Subject: XPR torch lead improvements

A summary of the changes for reference:

Phase 1

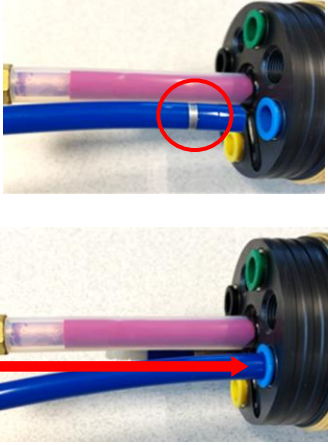
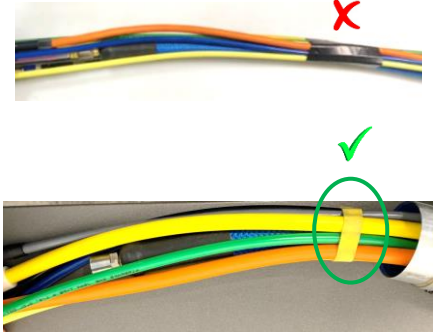
The change	The benefit	
<p>Addition of insertion witness depth marks on 6mm (1/4") tube ends</p>	<p>Allows the installer to visualize when the tubing has been fully inserted in the push to connect "legris" fittings of the torch receptacle.</p> <p>The silver band should not be visible if the tubing has been fully inserted.</p>	
<p>Extended electrical/fluid conductors around perimeter/Addition of 25mm (1") to all perimeter electrical/fluid conductors</p>	<p>Reduces the mechanical tension on the push to connect "legris" fittings, pilot arc and ohmic solder joints allowing for slack during cutting motion.</p>	
<p>Moved position of 75mm (3") wide tape away from high flex area of the torch lead/Addition of elastic support band to hold orientation</p>	<p>The yellow elastic support will hold proper lead orientation while allowing the lead to have free movement.</p>

Phase 2
Effective August 15, 2023

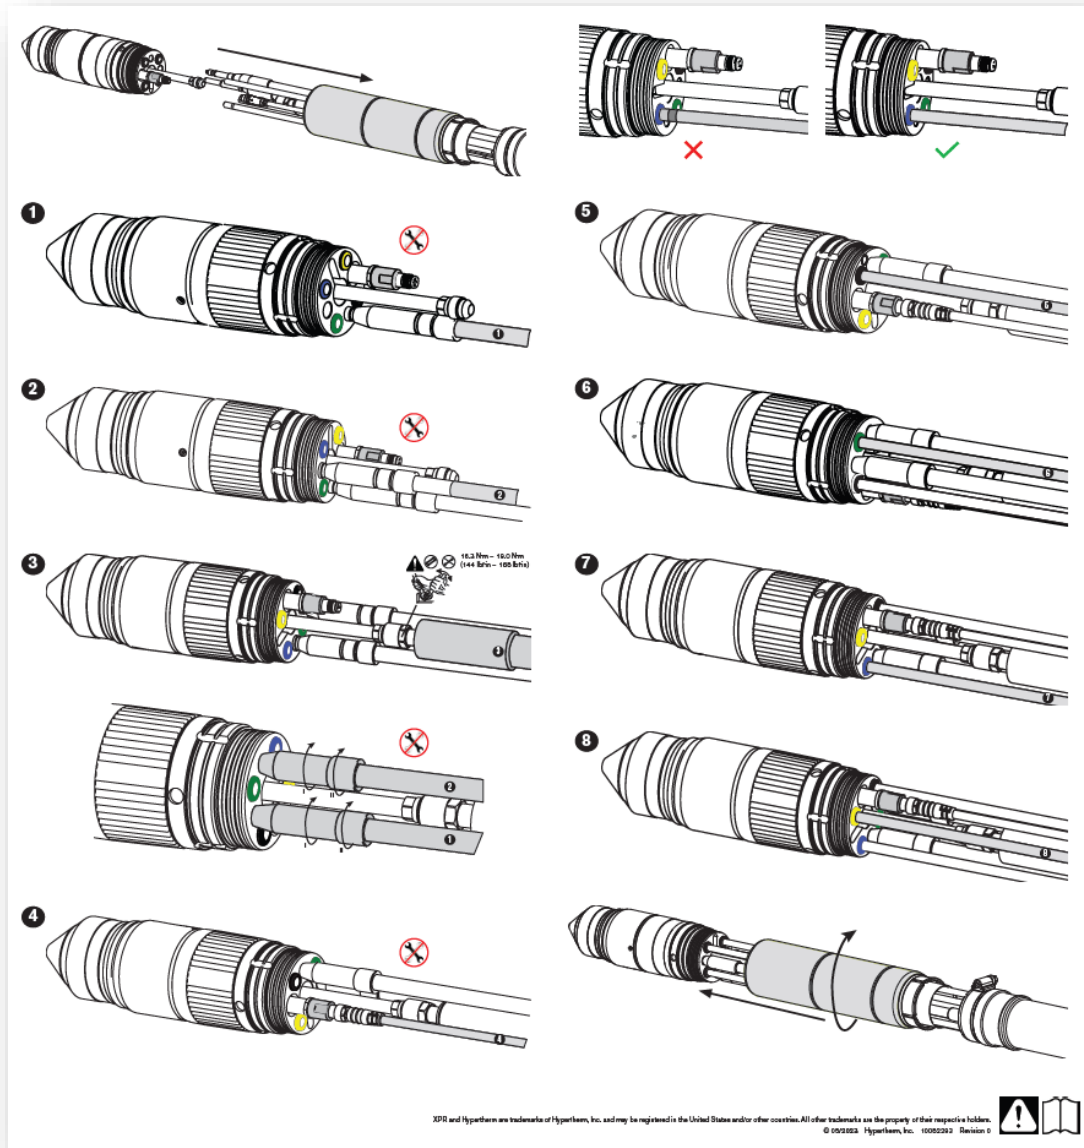
The change	The benefit	
<p>Switched from FireFlex® (sticky material) to InsuL THERM® protective lead cover/sheathing</p>	<p>Easier to route thru C track and some bevel head designs because slides do not stick.</p> <p>Improved durability</p>	<div style="display: flex; justify-content: space-around;"> <div style="text-align: center;"> <p>InsuL THERM</p>  </div> <div style="text-align: center;"> <p>FireFlex</p>  </div> </div>
<p>Added strain relief to the Pilot and Ohmic lead connectors</p>	<p>Improved durability by removing flex of cable on solder joint to reduce mechanical stress which is especially critical with bevel heads and Robotic applications.</p> <p>Note: New FSB (10082293) includes proper installation of the ohmic and pilot lead.</p>
